LIBERTY PARK

AN ADDITION TO WICHITA, SEDGWICK COUNTY, KANSAS

RE: SUB 2002-41 -- Final Plat of Liberty Park Addition

CASE NUMBER: SUB 2002-41 -- LIBERTY PARK ADDITION

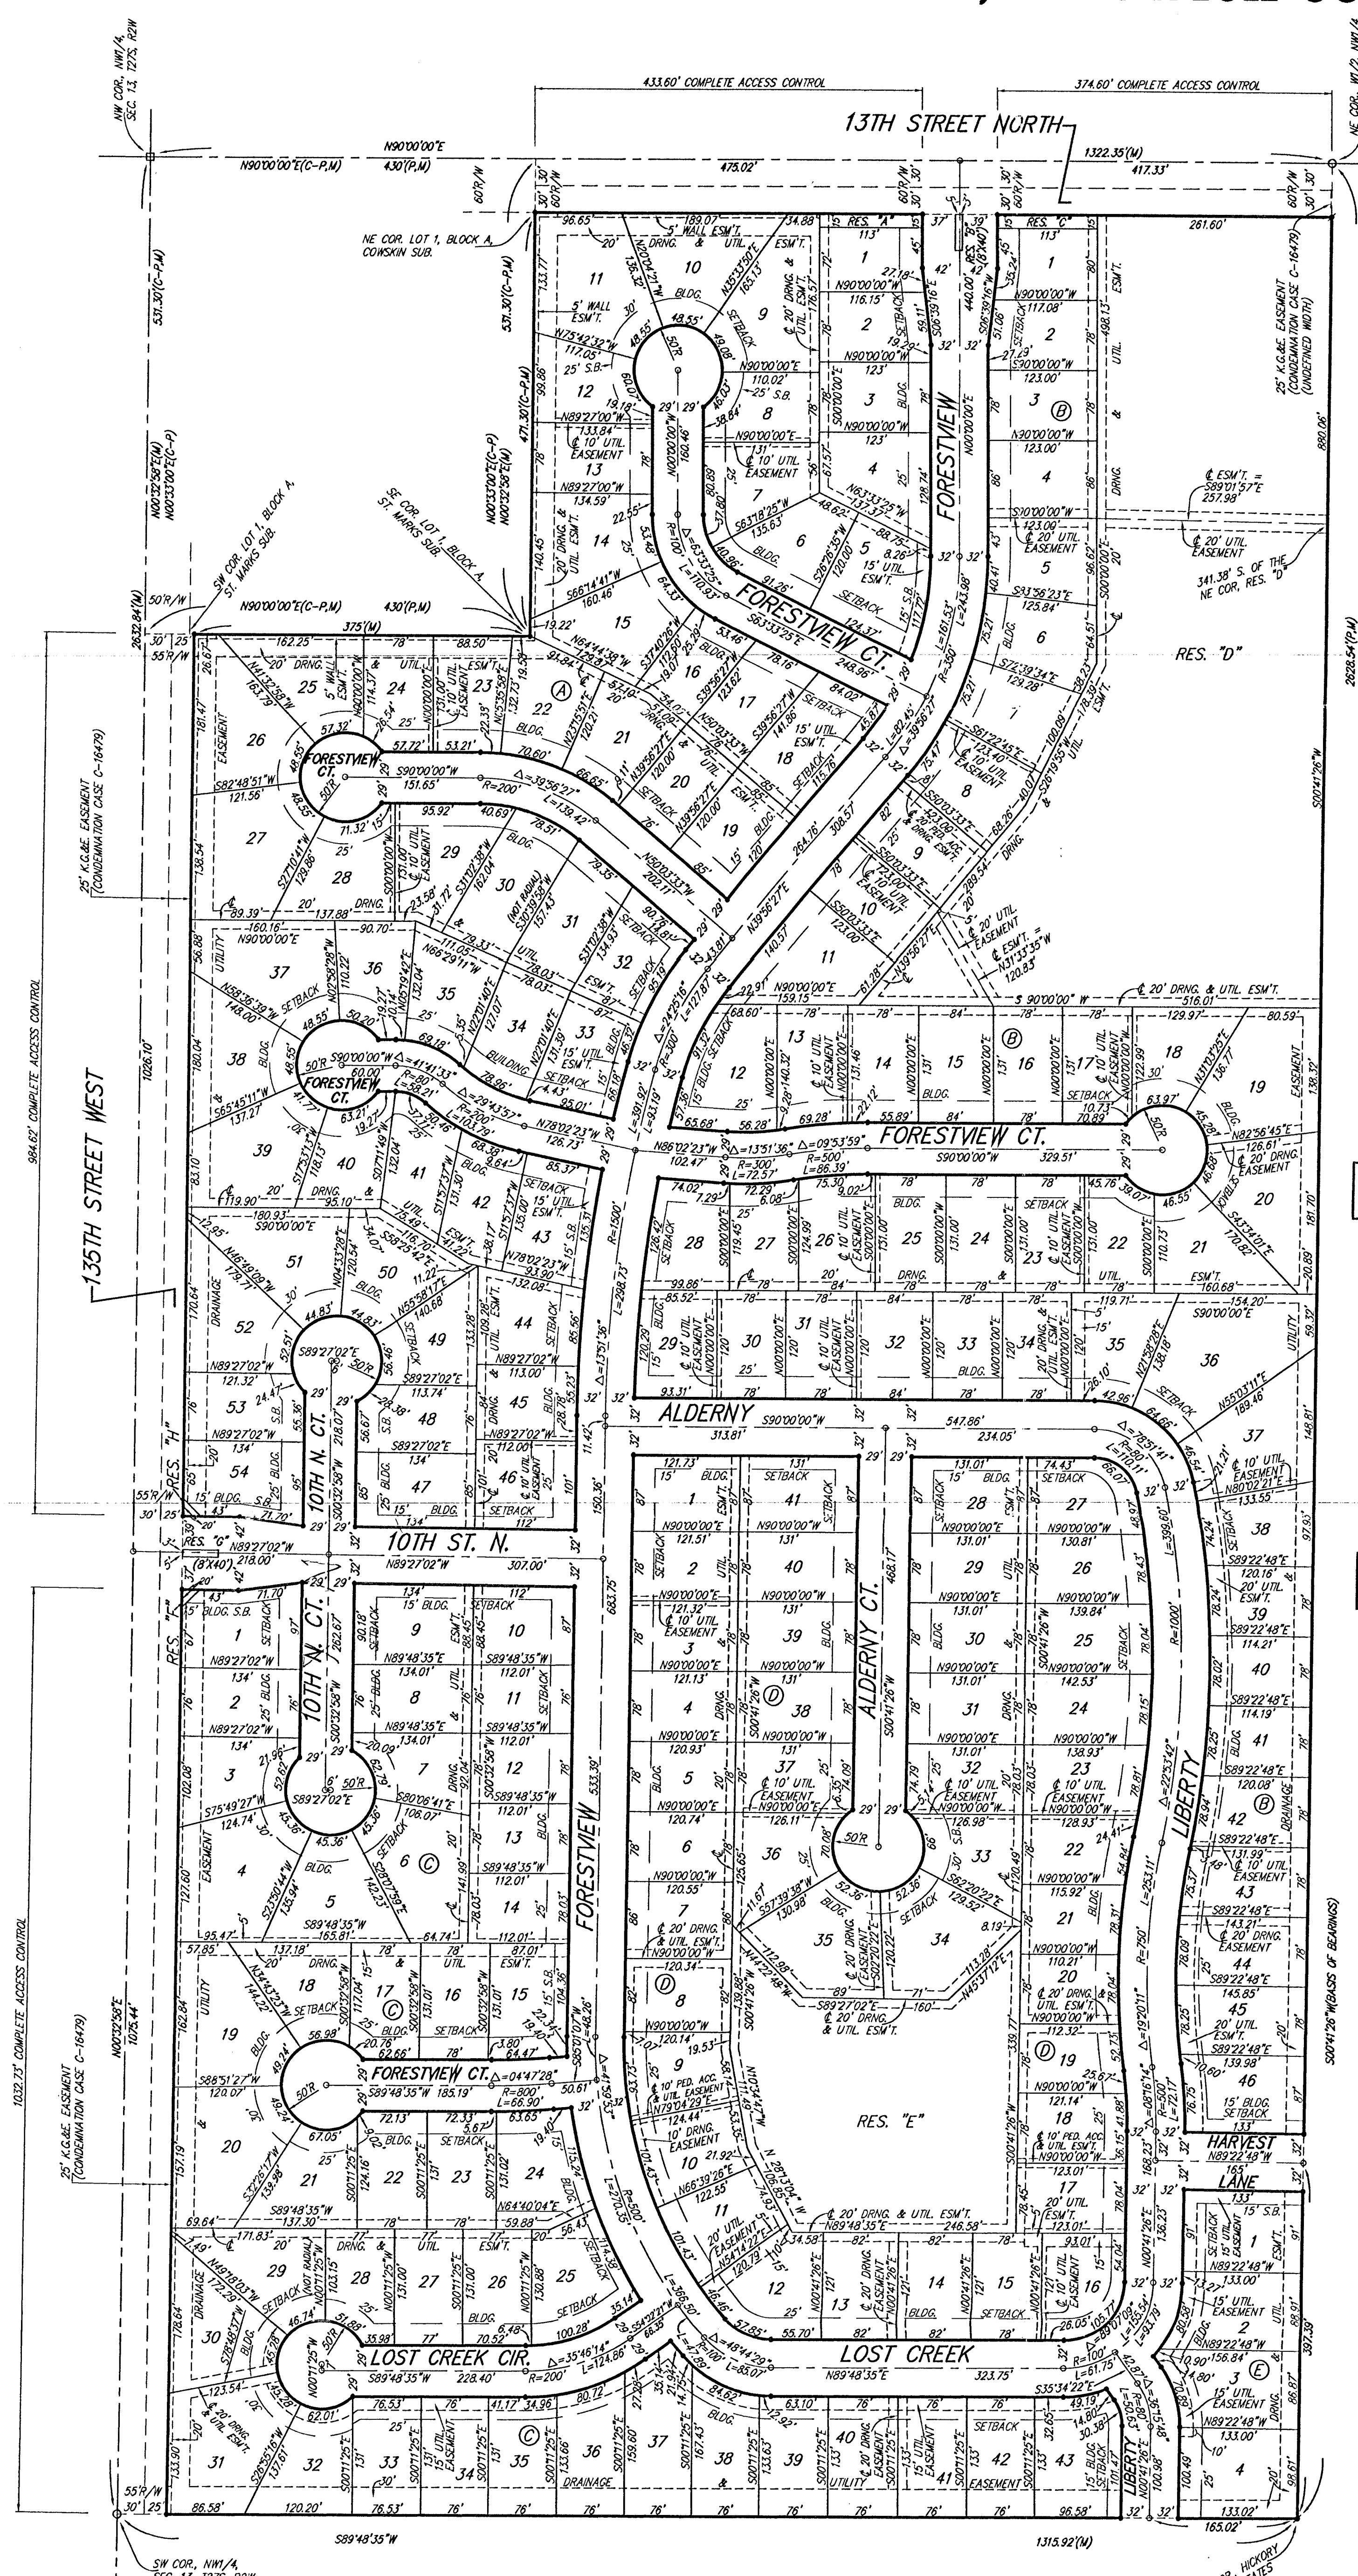
- F. A street stub should be shown to the south for increased mobility when development occurs in this location.

- G. The Applicant shall guarantee the paving of the proposed streets. The guarantee shall also provide for sidewalks on at least one side of all through, non cul-de-sac streets.
- H. It is recommended that Reserves D and E be extended to the streets by access easements or by extensions of the Reserves between the lots to increase their accessibility and usefulness for all homeowners in the Addition

- L. The wall easement shall be referenced in the plat's text.
- M. The City Fire Department/GIS needs to comment on the plat's street names. 10th N. Ct. should be revised to 10th Ct. N.

- N. For any lots with existing tree rows that may be impacted by the installation of utilities, it is recommended that 30-ft utility easements be platted in order to allow for the installation of the utilities without damage to such tree rows. The applicant has agreed to plat an appropriate easement to avoid damage to the tree row.

- O. The plat's text shall include language that a drainage plan has been developed for the plat and that all drainage easements, rights-of-way, or reserves shall remain at established grades or as modified with the approval of the applicable City or County Engineer, and unobstructed to allow for the conveyance of stormwater.

- W. The representatives from the utility companies should be prepared to comment on the need for any additional utility easements to be platted on this property. Westar Energy has requested additional easements.

The applicant has extended Liberty to the south line of the plat as requested.

Pedestrian easements have been platted as requested.
